DATE: January 16, 2020

FROM: Wight & Company
2500 N. Frontage Road
Darien, IL 60561

SUBJECT: **ADDENDUM #3 TO THE BIDDING DOCUMENTS FOR:
NORTH HIGH SCHOOL BID GROUP #10
MASTER FACILITY PLAN IMPLEMENTATION
COMMUNITY HIGH SCHOOL DISTRICT 99
NORTH HIGH SCHOOL
4436 MAIN STREET
DOWNERS GROVE, IL 60516**

Sheet E5.02.c RISER DIAGRAM (PHASE C) **(Full size sheet reissued)**:

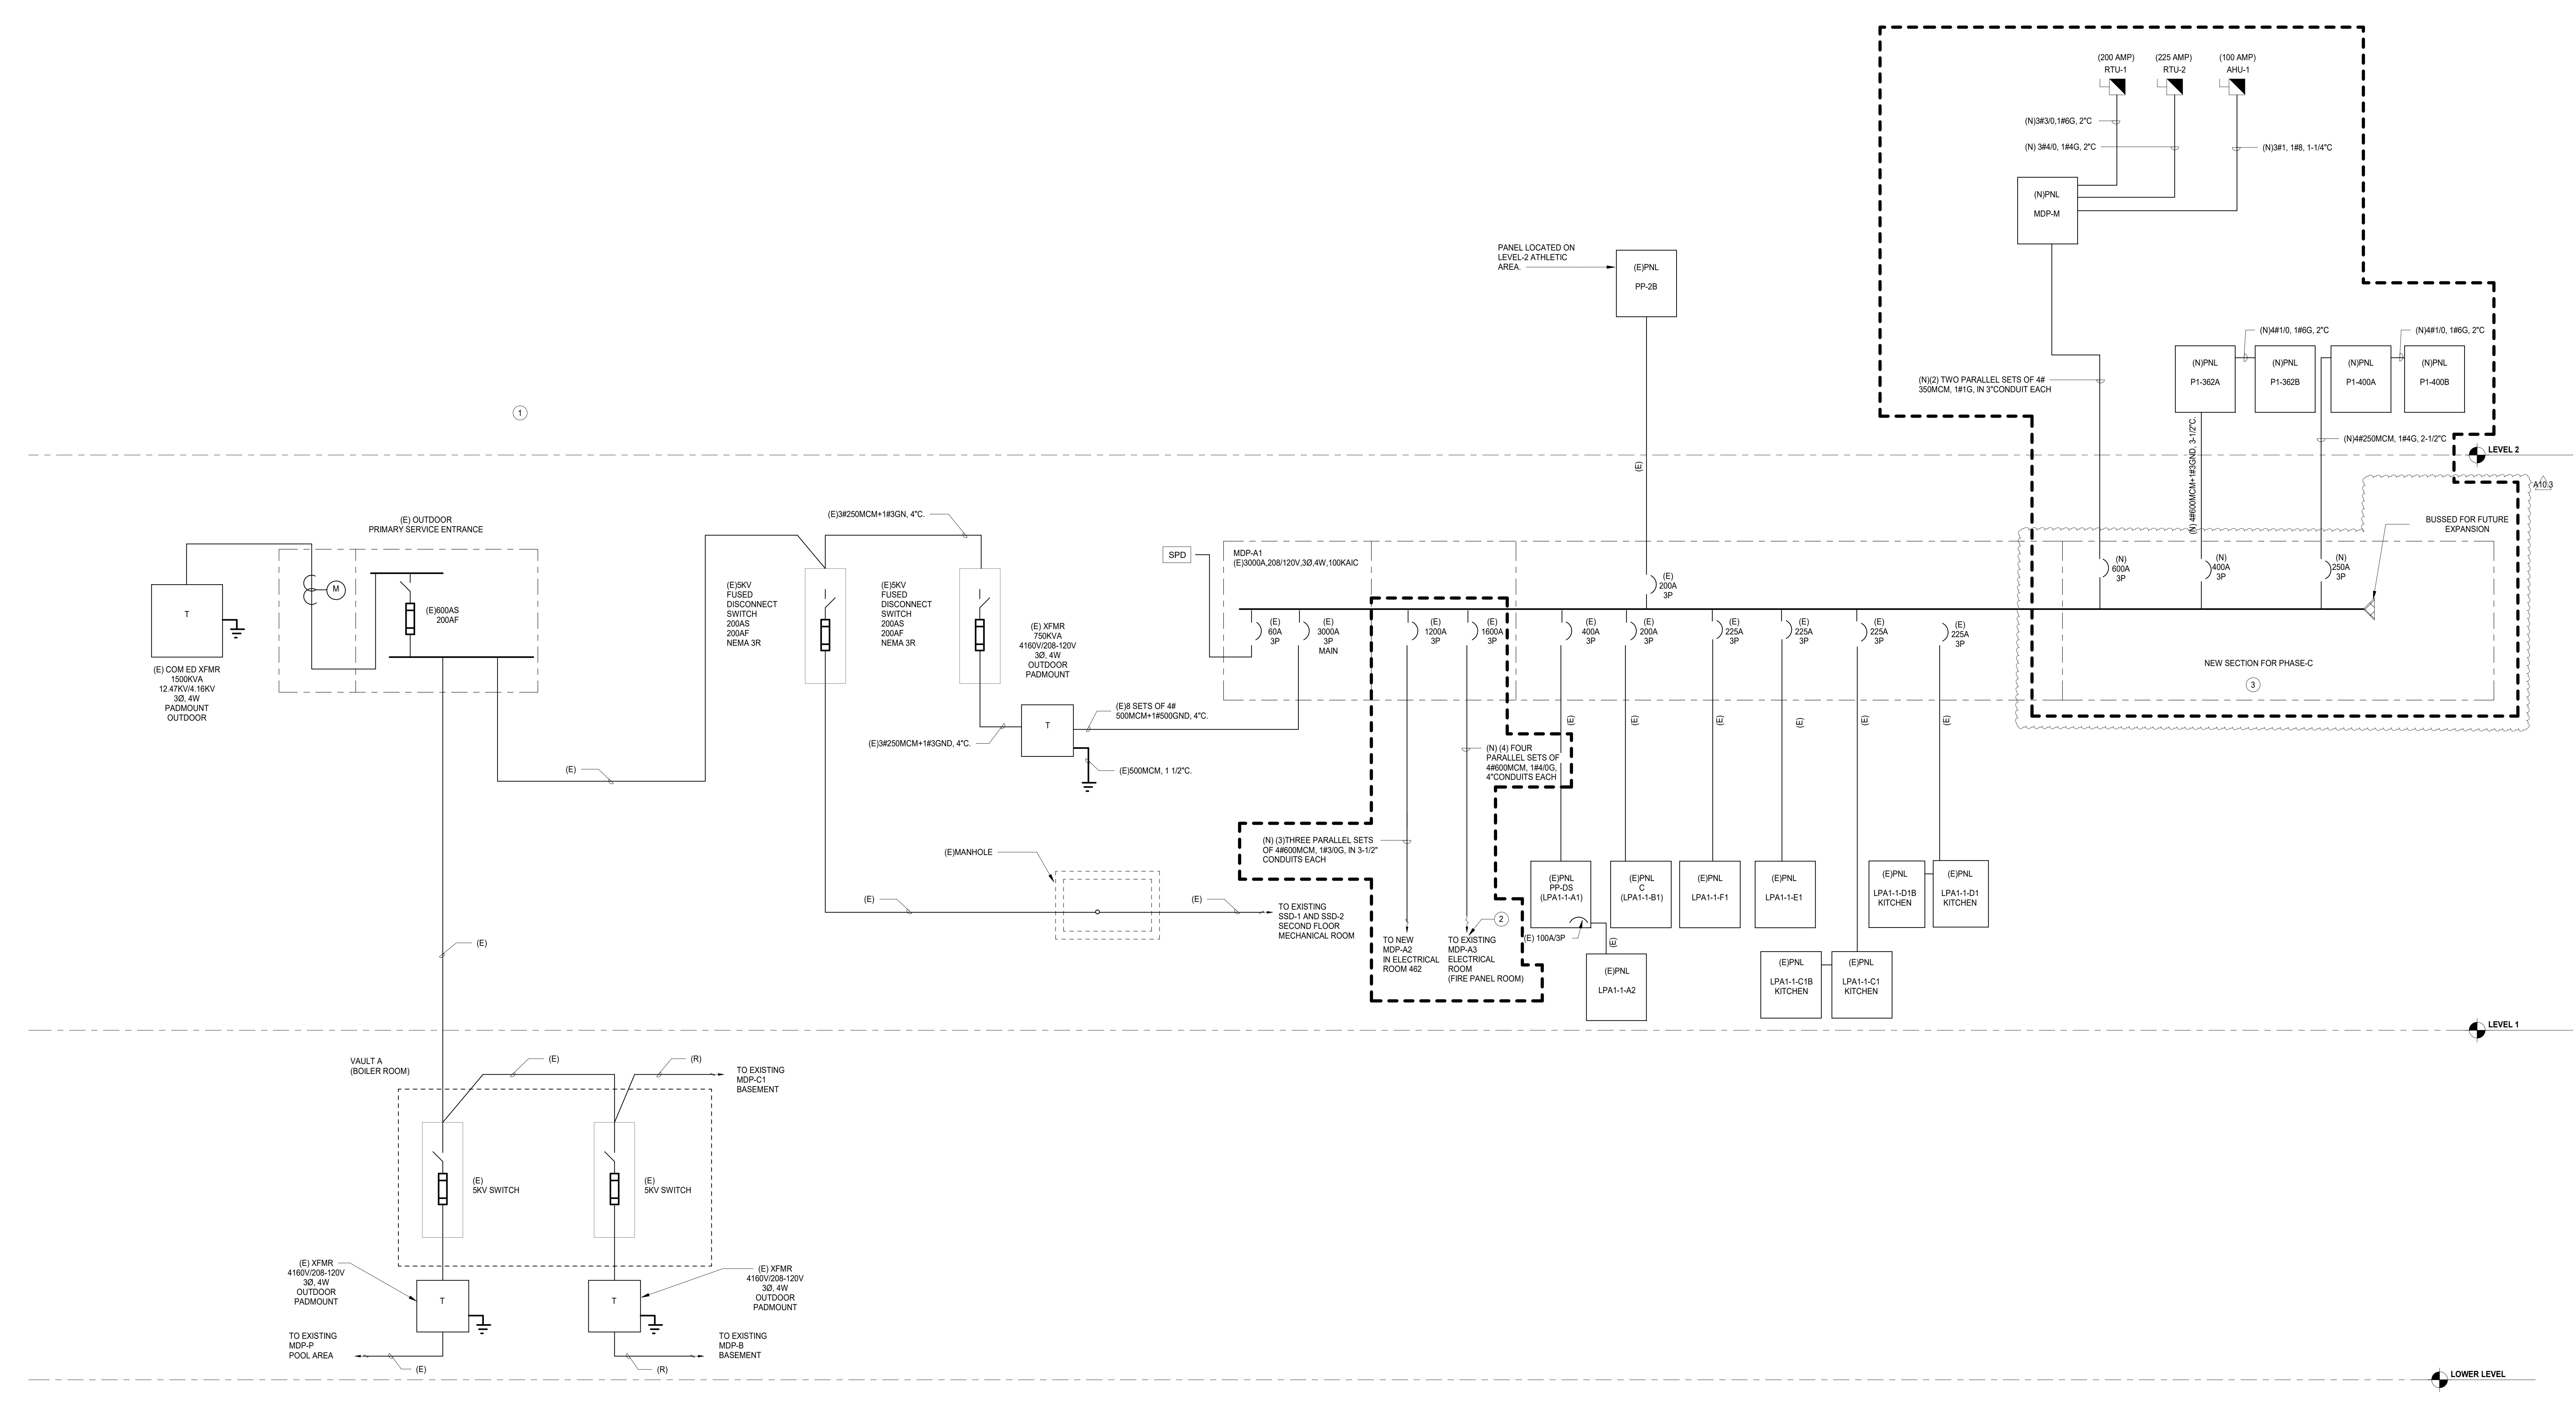
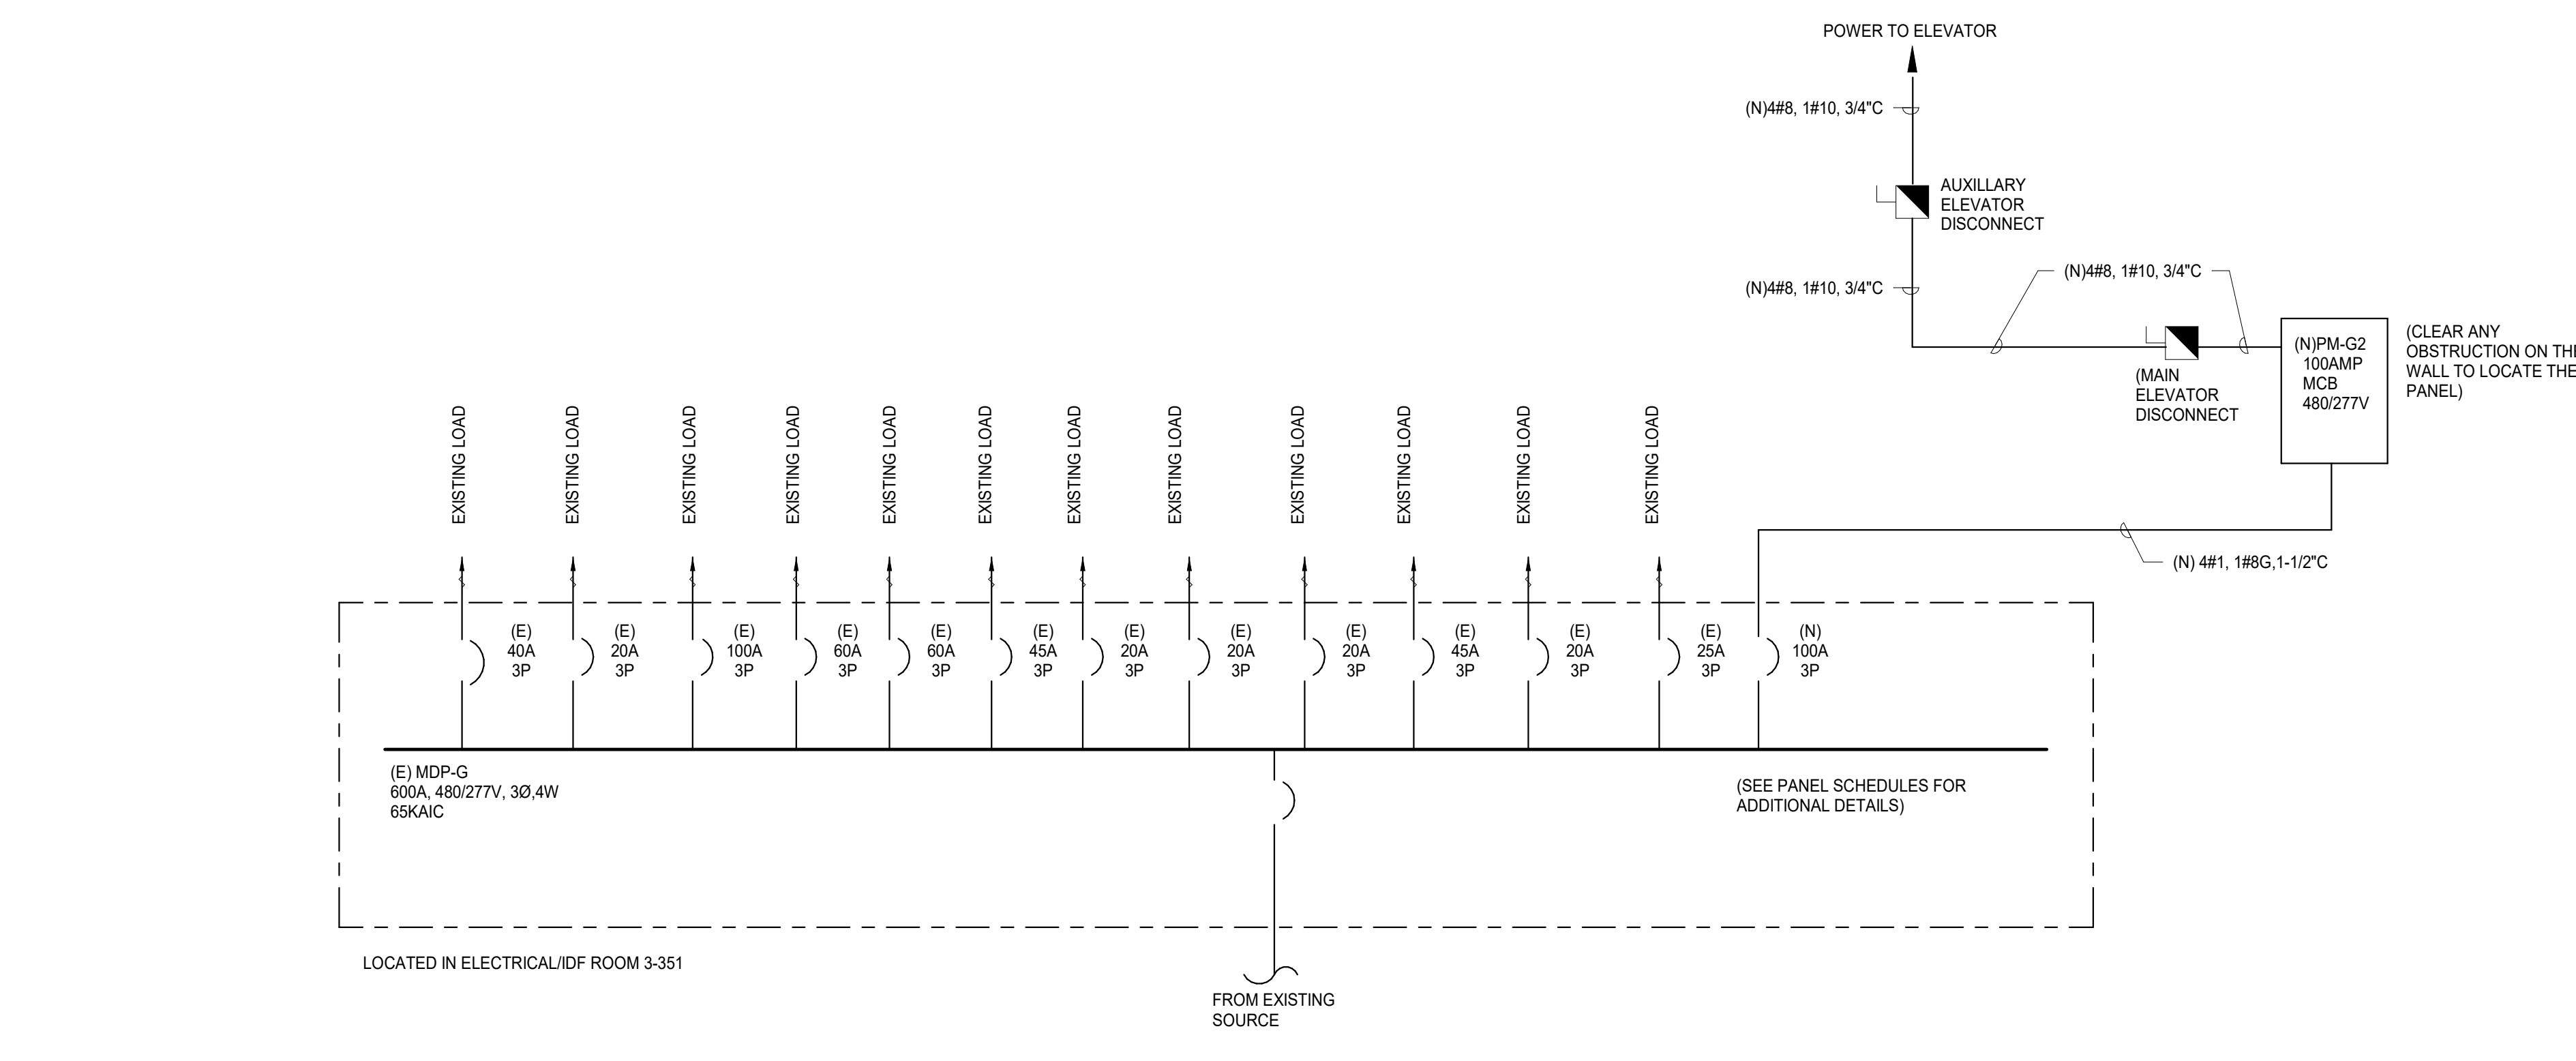
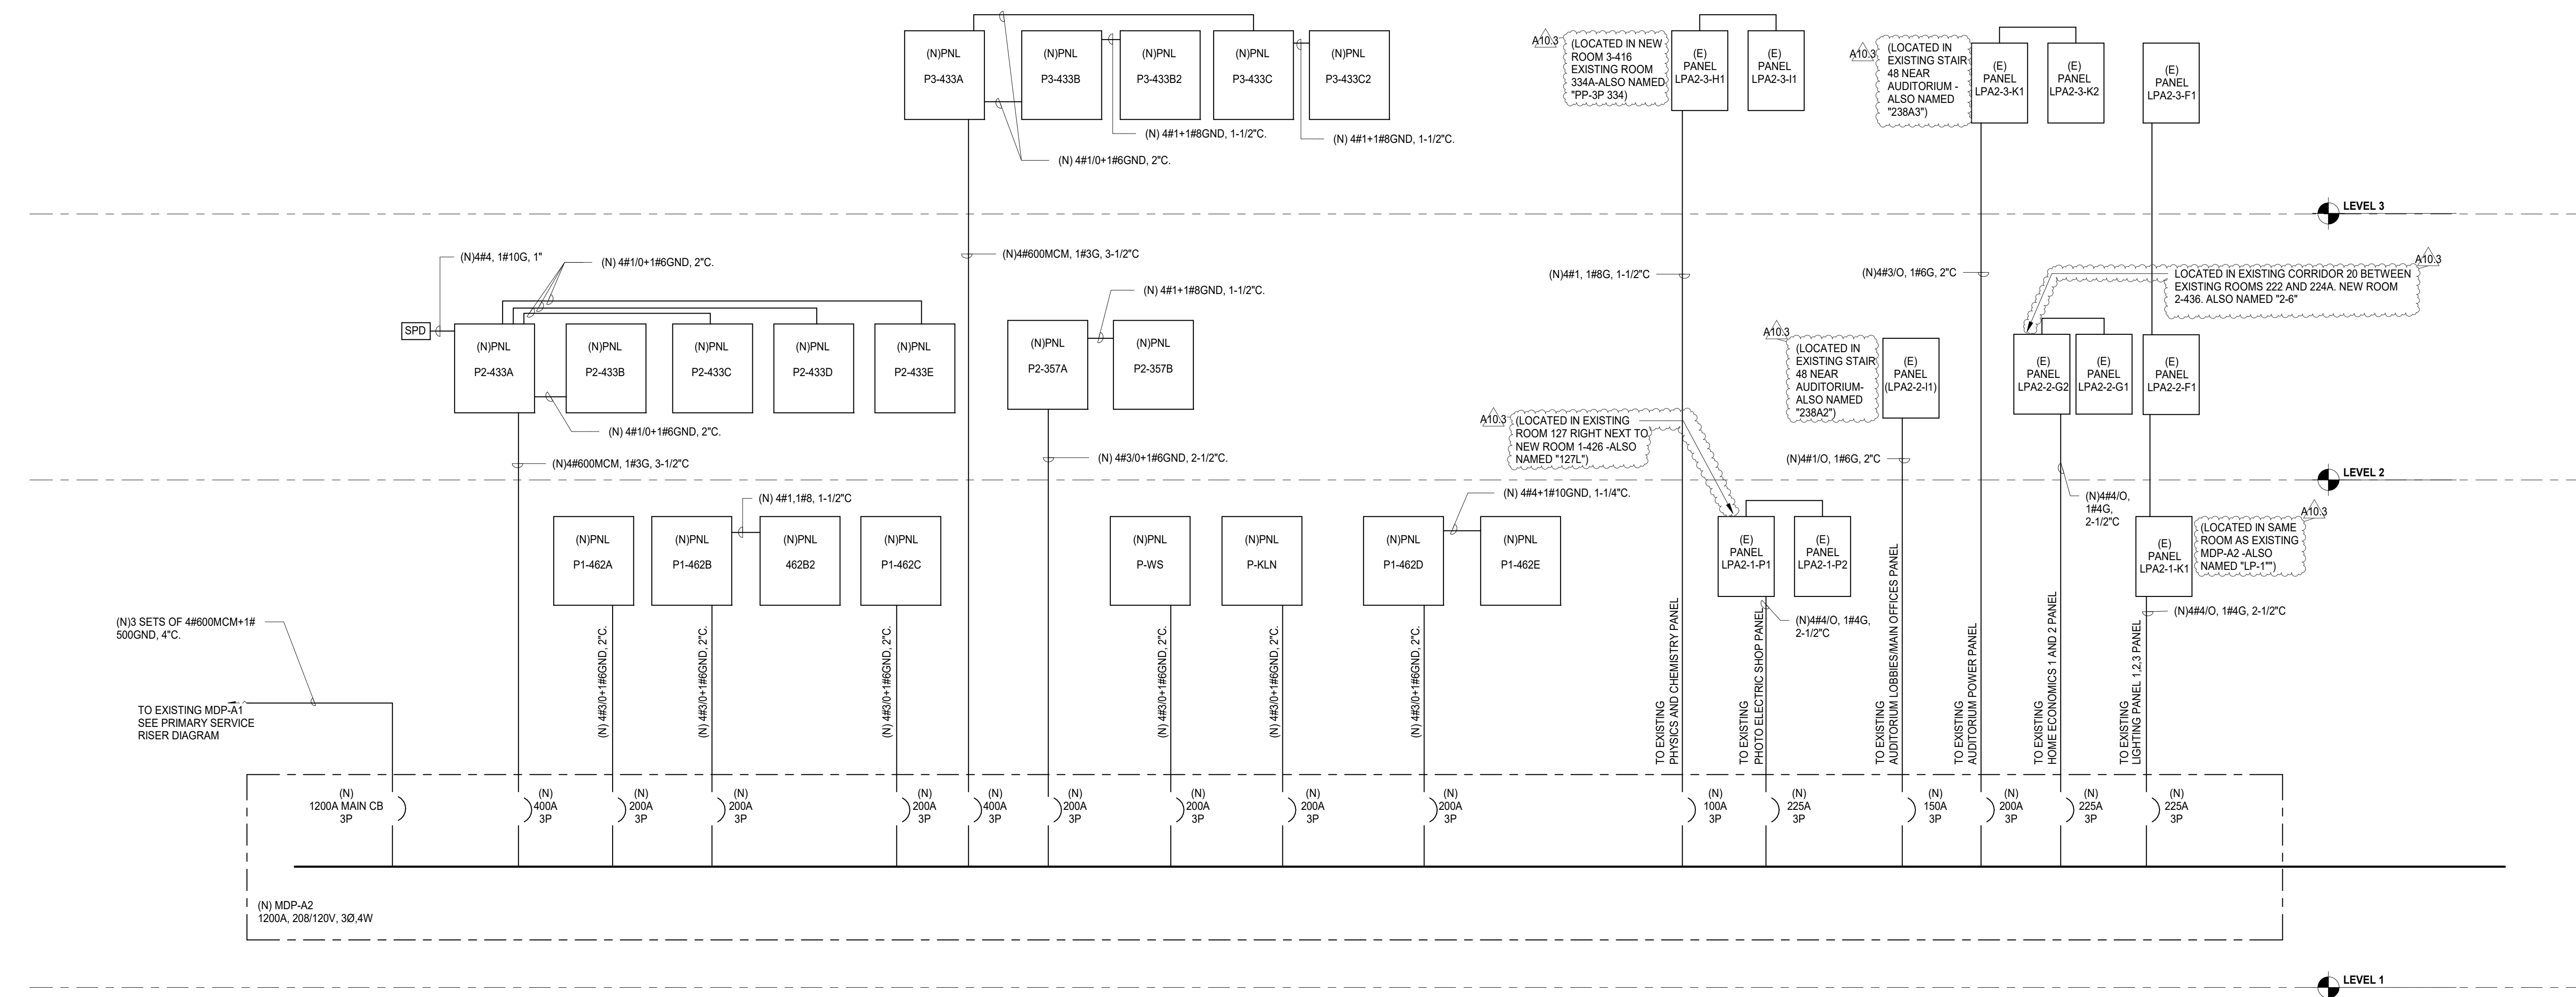
13.	I see panel BPA on E2.00B.c but it is not on the riser and the origin of its new feed is not shown. Please let us know where to take the feed from	1-9-20	Addendum #3 - Refer to revised riser diagram on Sheet E5.02.c.	1-14-20

32.	Drawing E5.02.c shows new feeder to existing panels as highlighted Can we be given these panel locations so we can figure the appropriate feeder lengths	1-8-20	Addendum #3 - Refer to revised riser diagram on Sheet E5.02.c	1-14-20 DS
